**ADDENDUM NO. 001**

**RE:** Sullivan County Department of Education – Ketron Elem. School Partial Roof Replacement  
T&L Project No. 17118

**DATE:** March 3, 2023

Sheet No. AD101

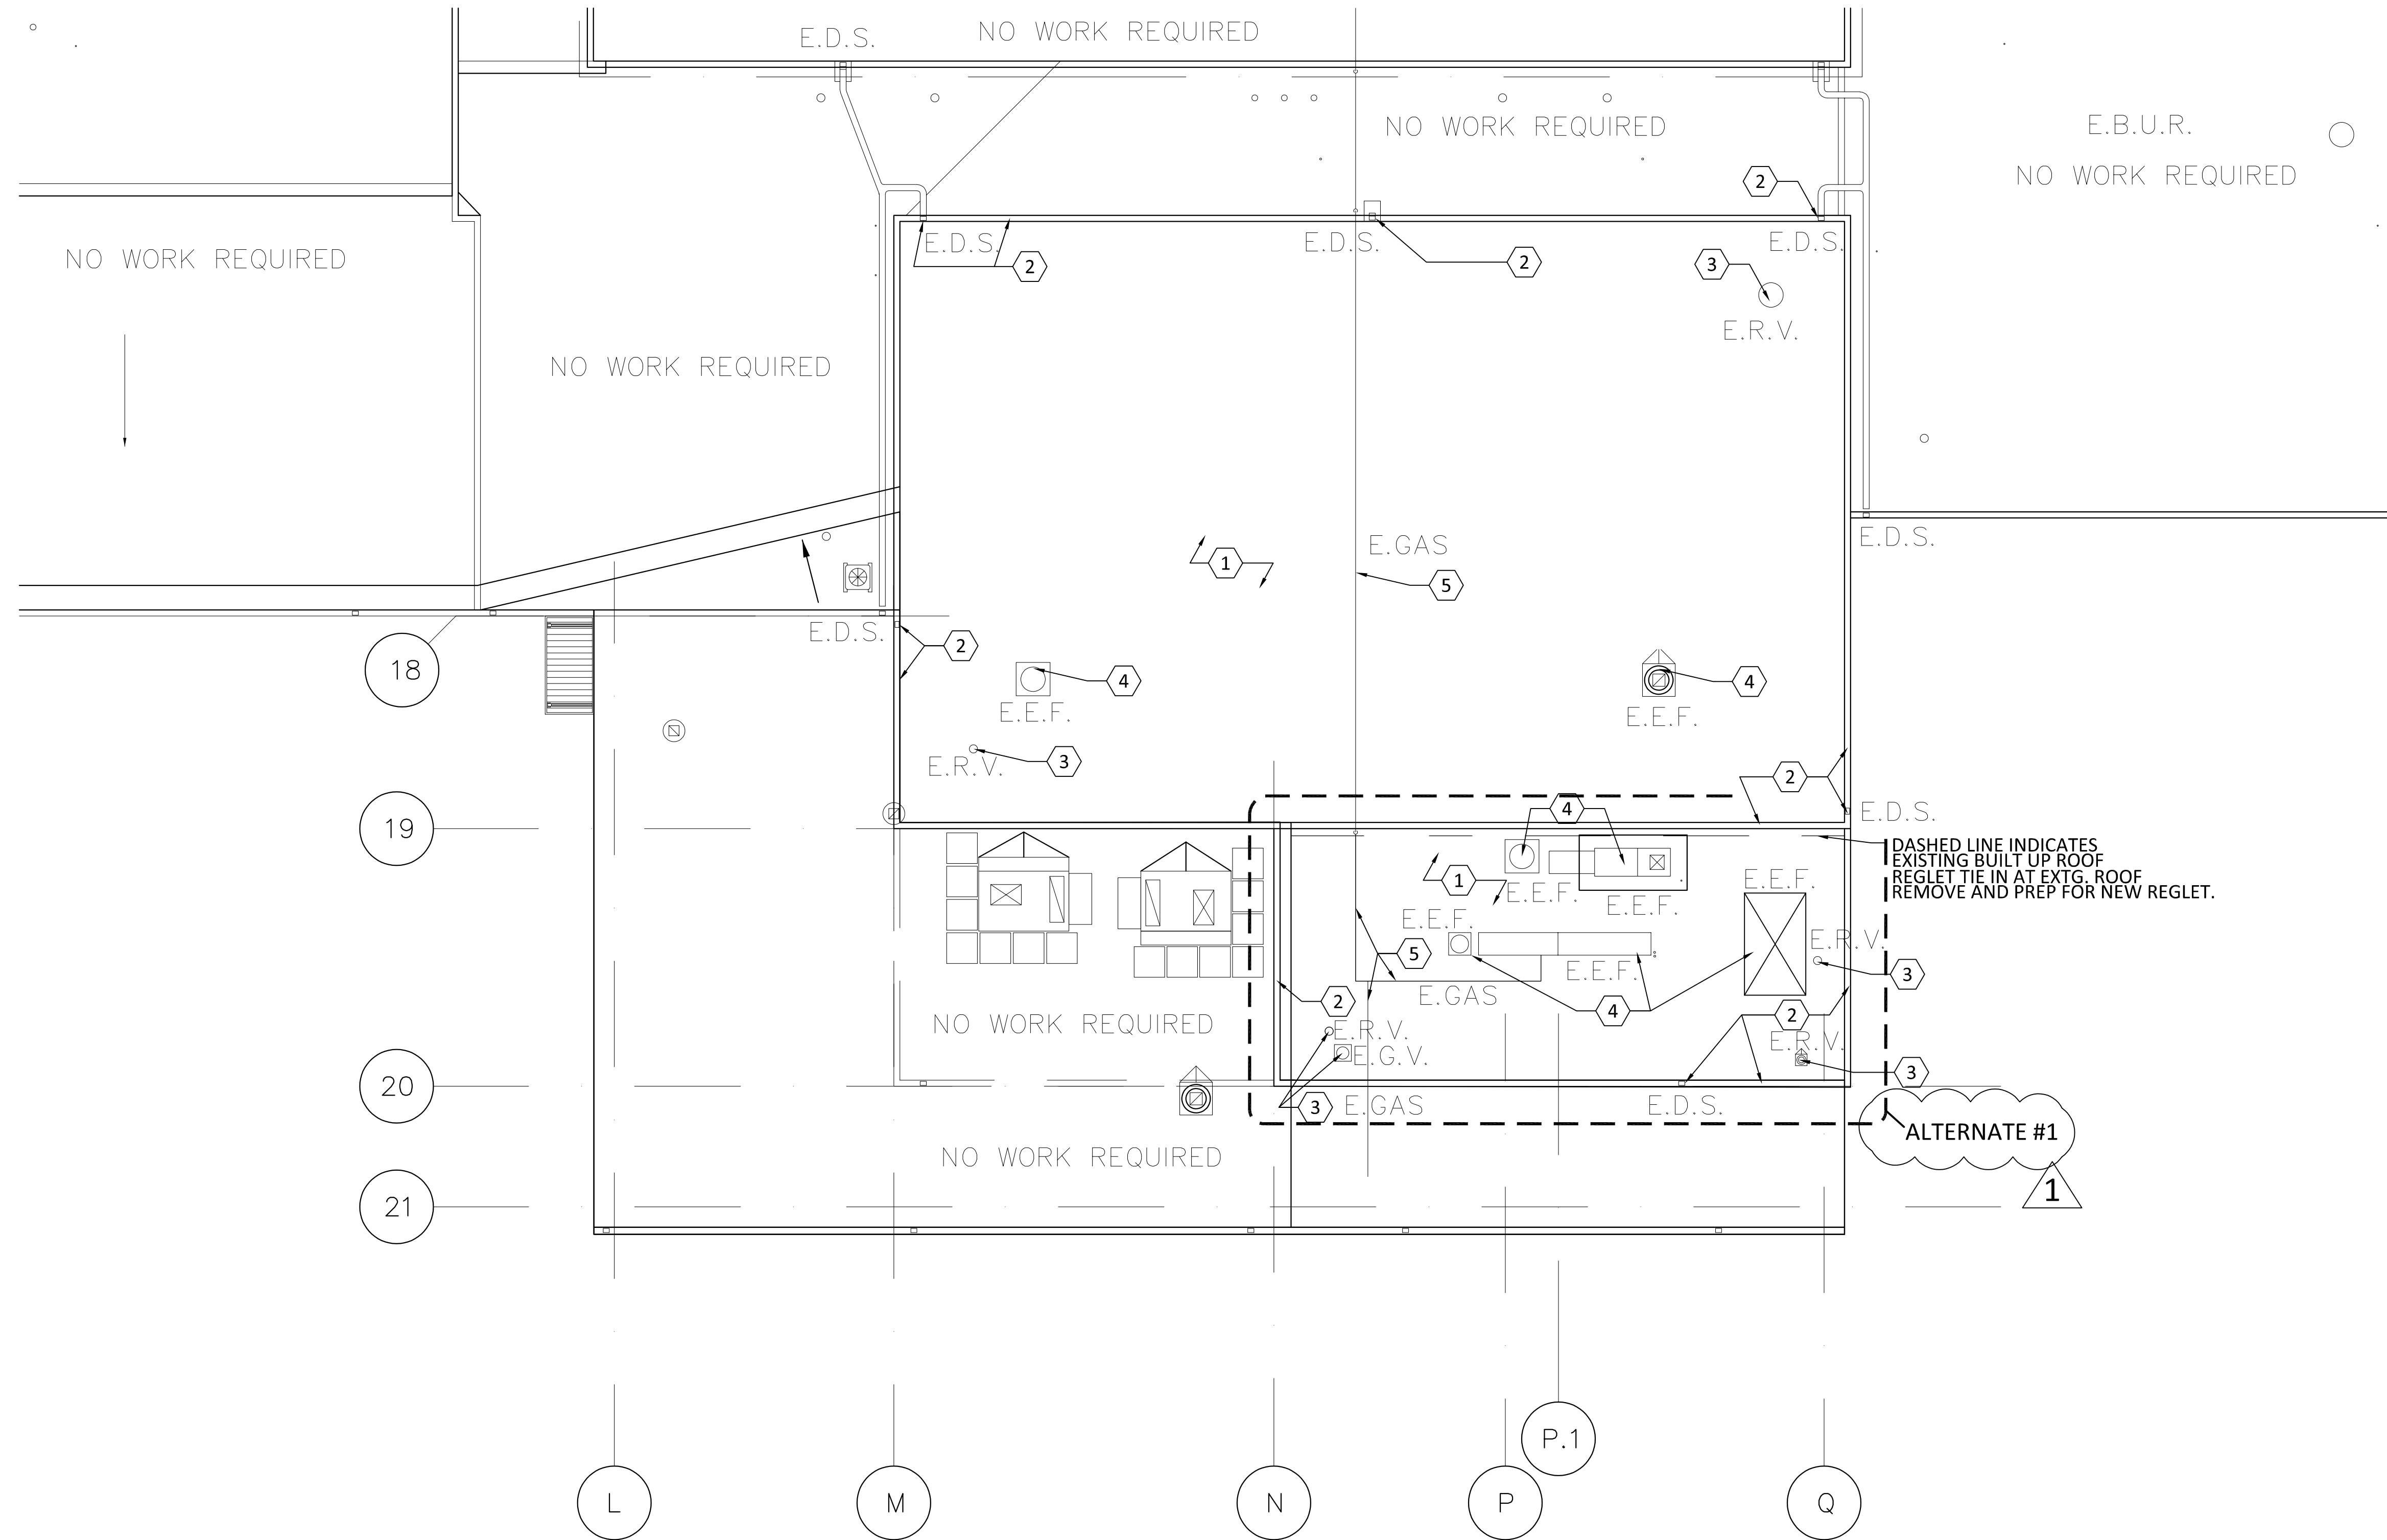
1. Drawing Sheets AD101, A101, & A102 are revised to added alternate #1 with details and notes.

No.	1
Date	3/3/2023
Purpose of Document Issue	ALTERNATE #1 & ADDED DETAILS/NOTES

ALTERNATE #1

- A. Add Alternate No. 1: Lower Existing Built up roof to be replaced. Refer to drawings for details and extend of scope of work.

Sheet No. **A101**

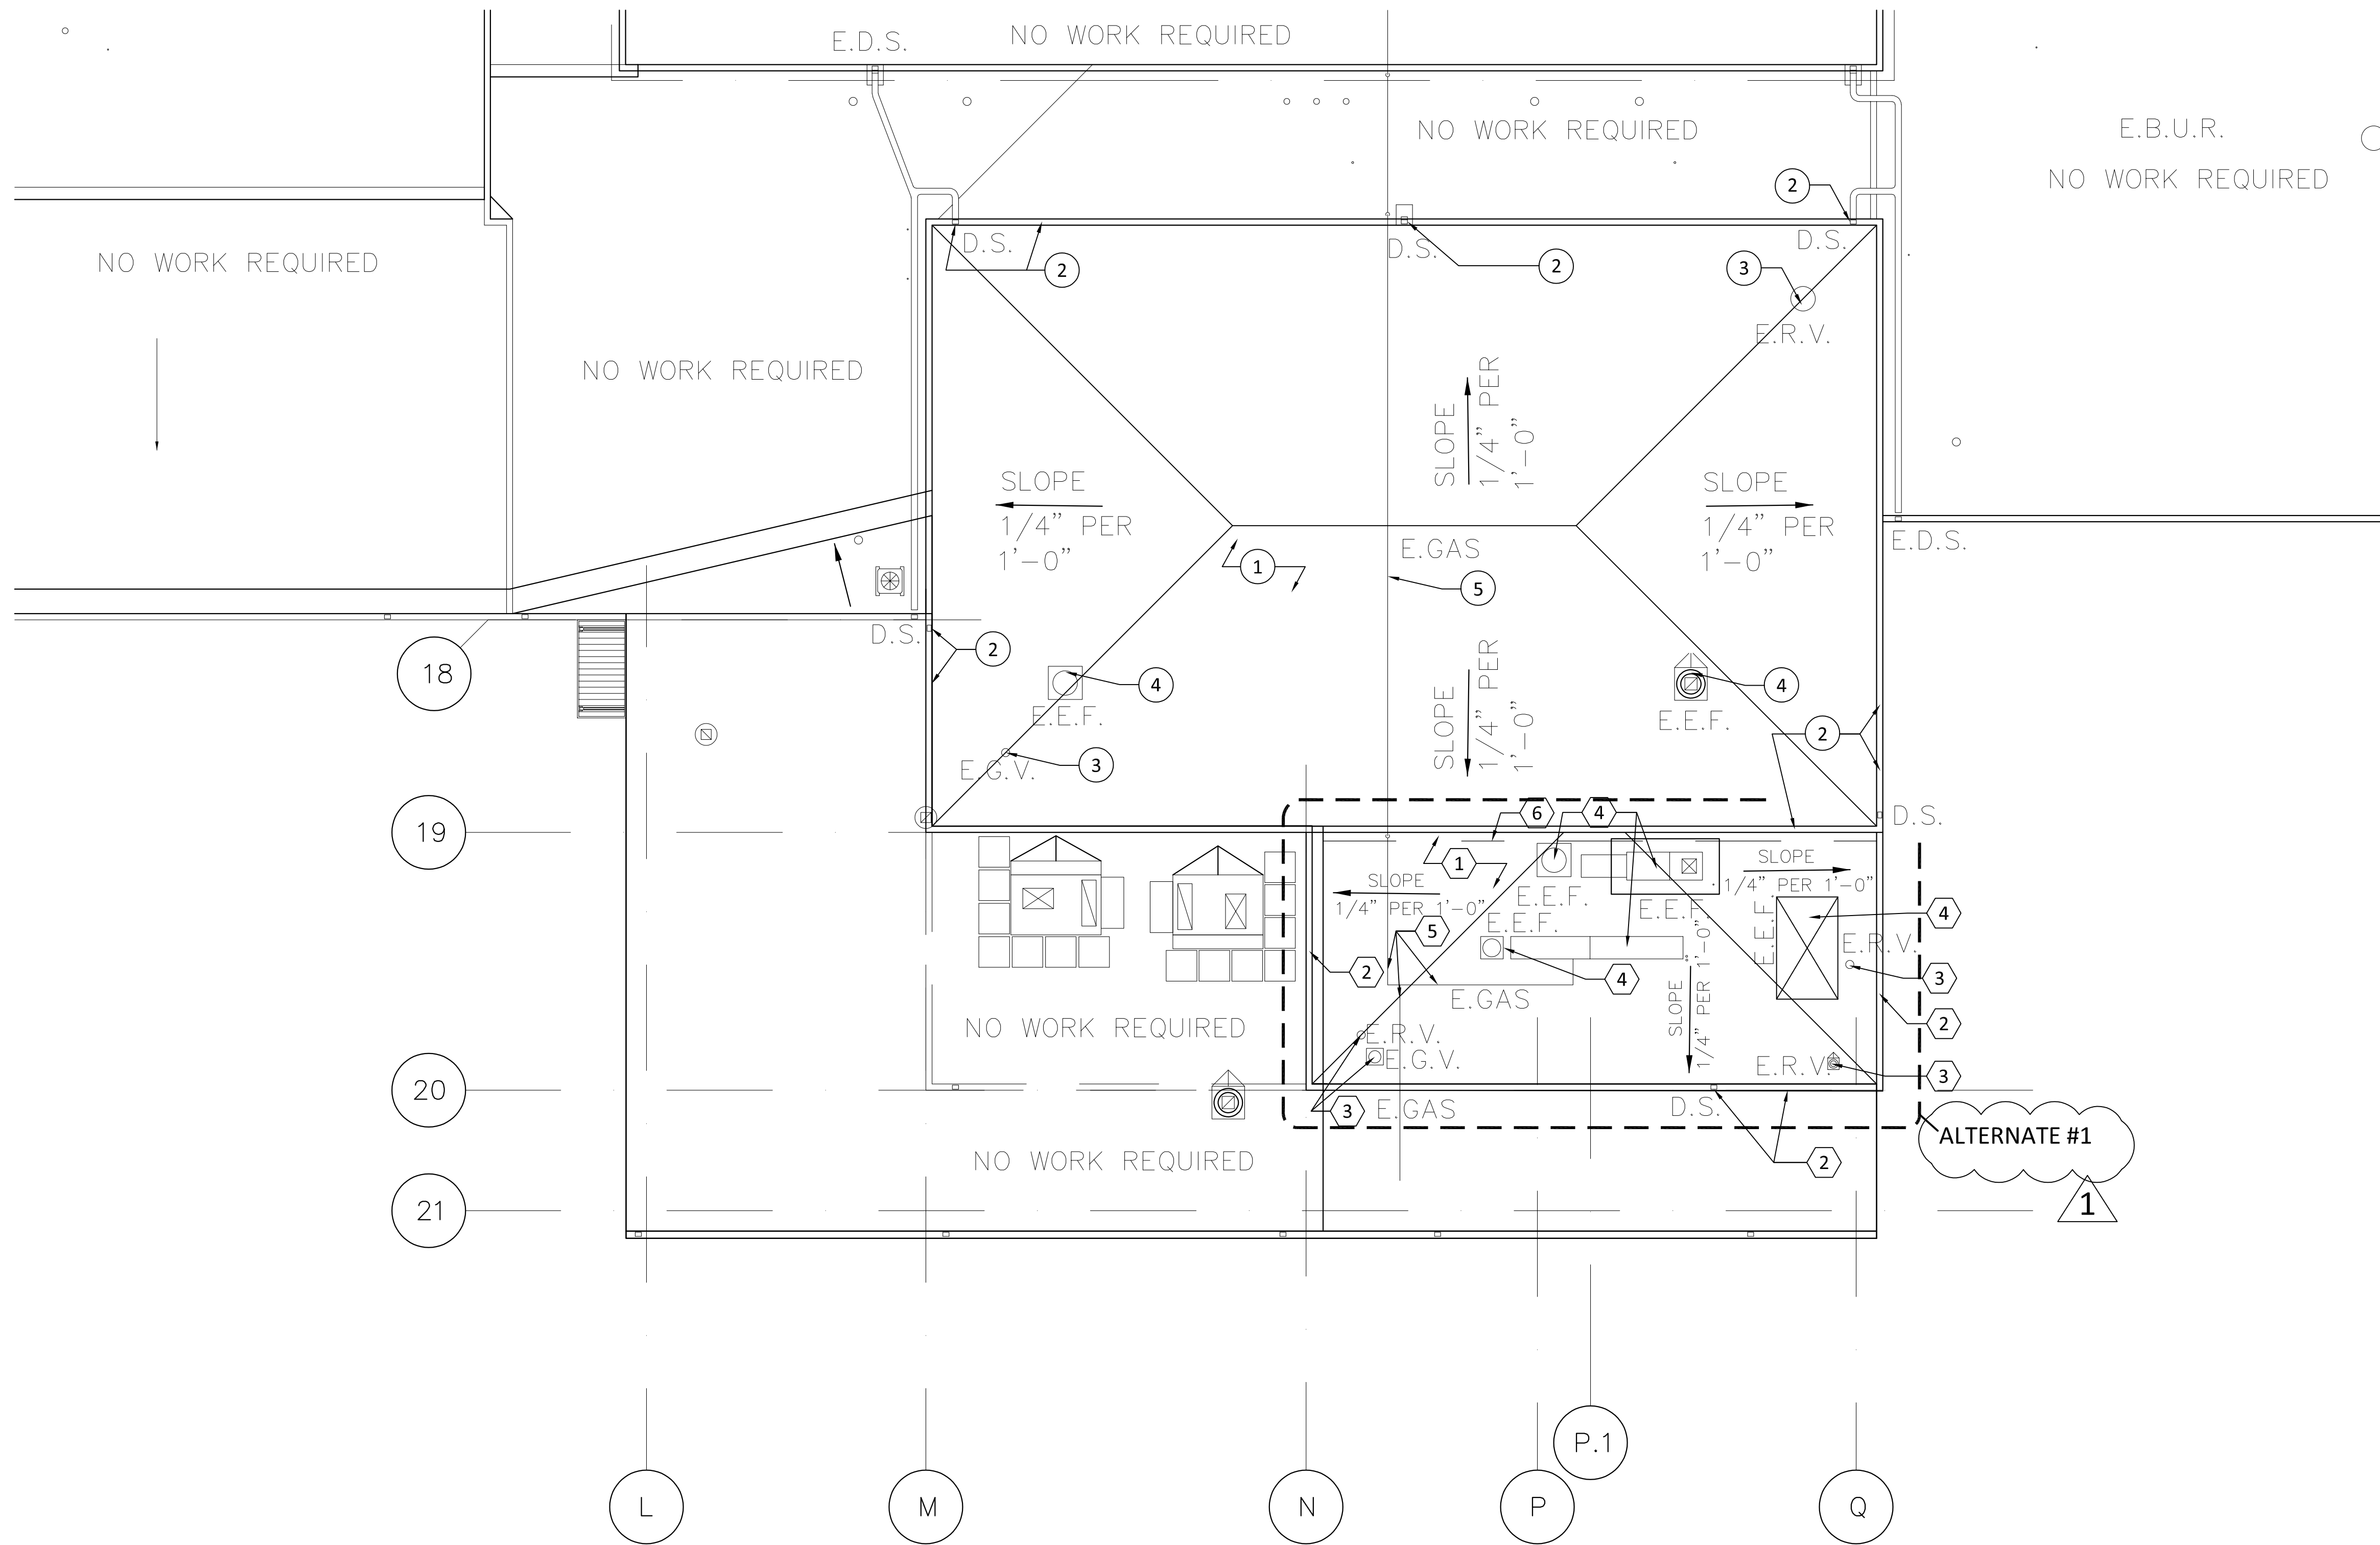
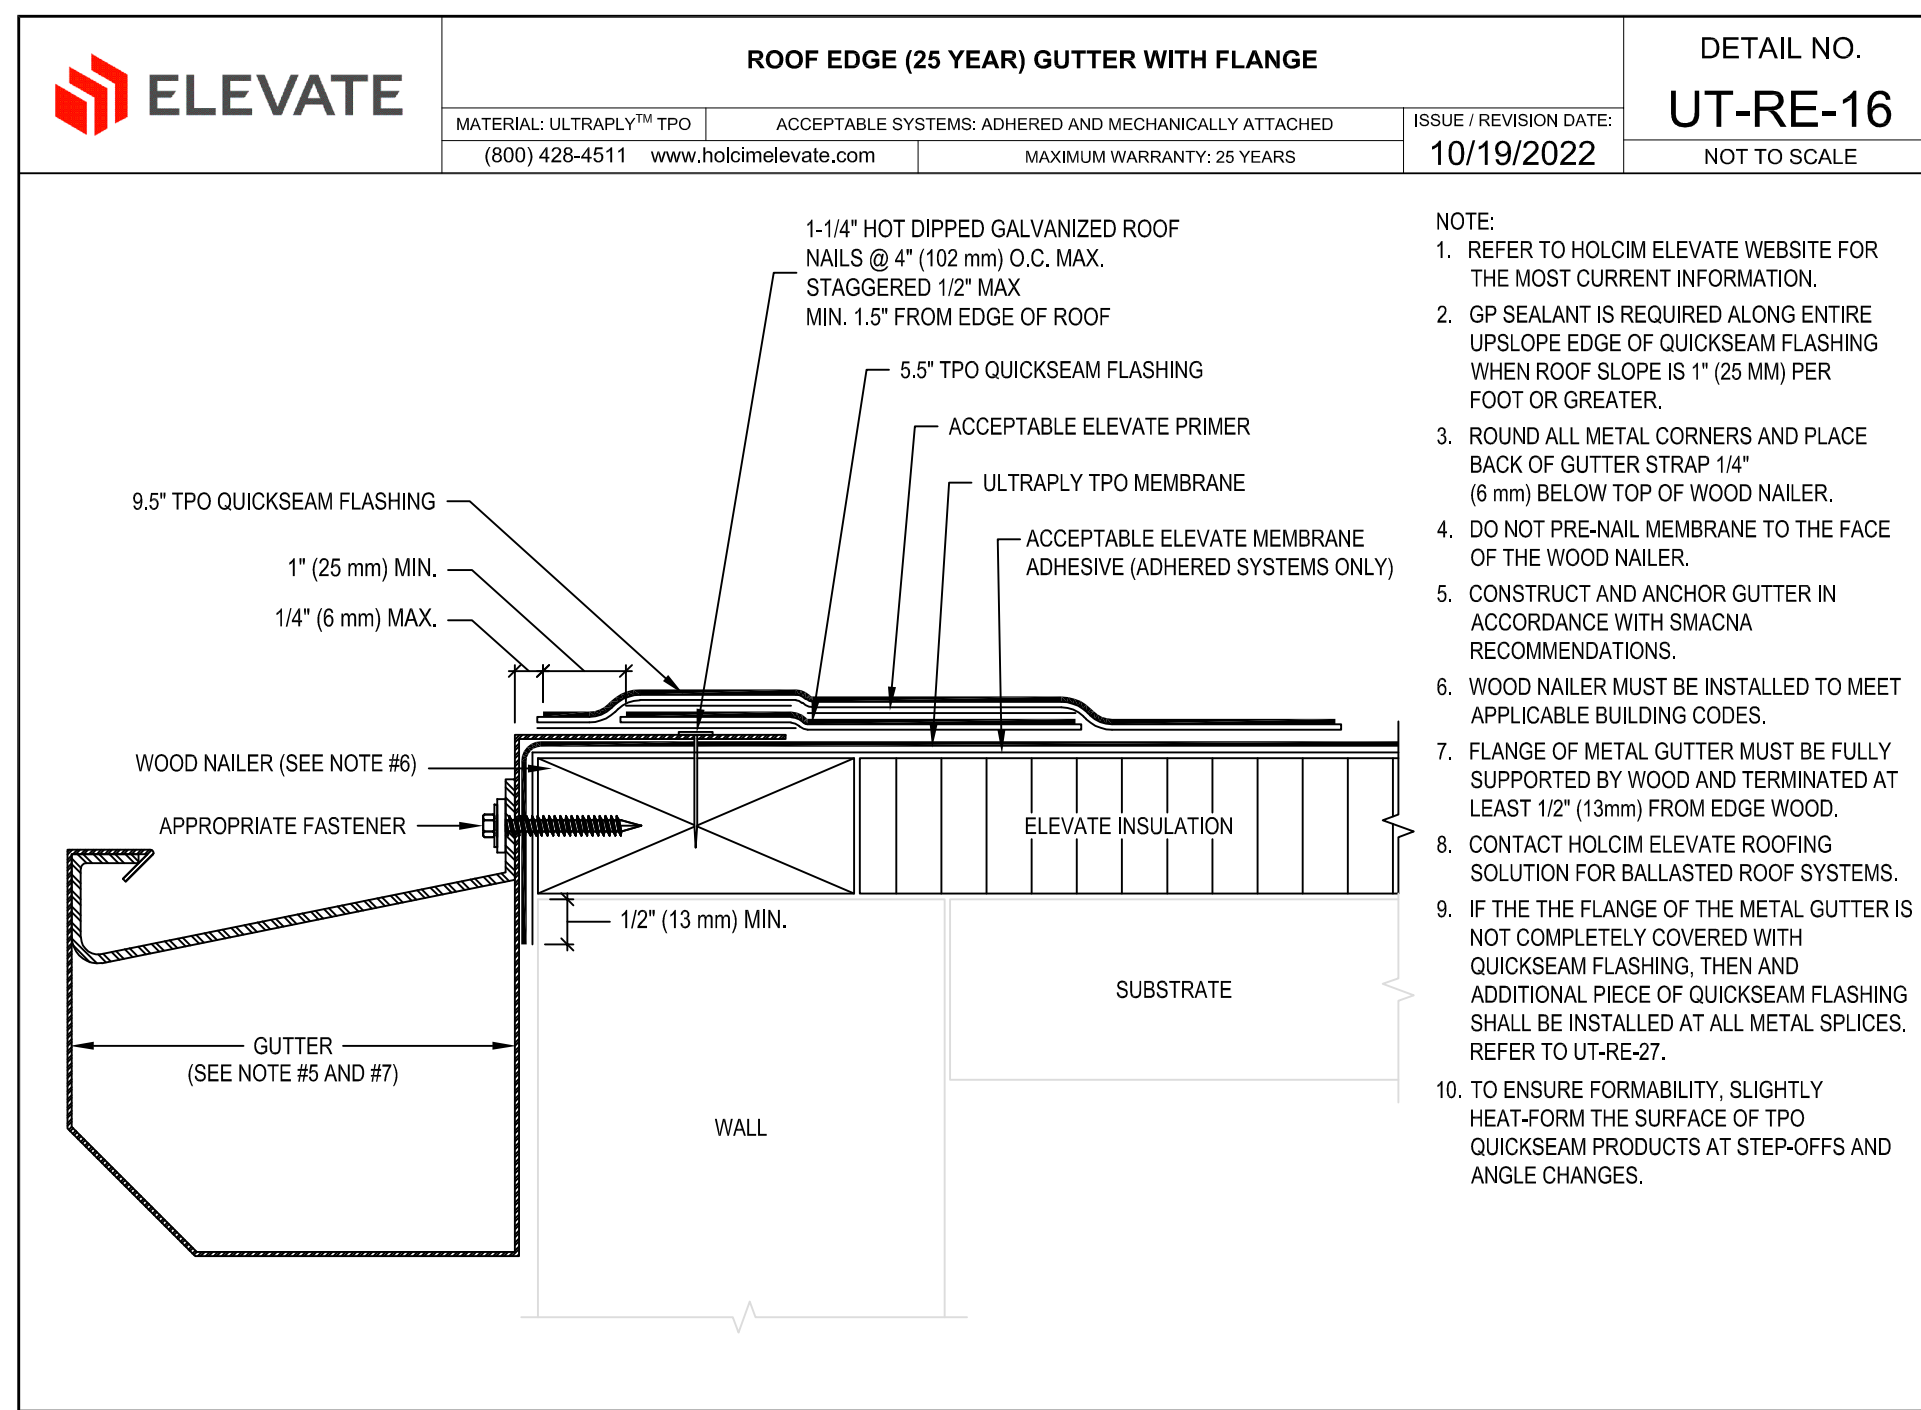
Purpose of Document Issue	
No.	ALTERNATE #1 & ADDED DETAILS/NOTES
Date	3/3/2023
No.	1
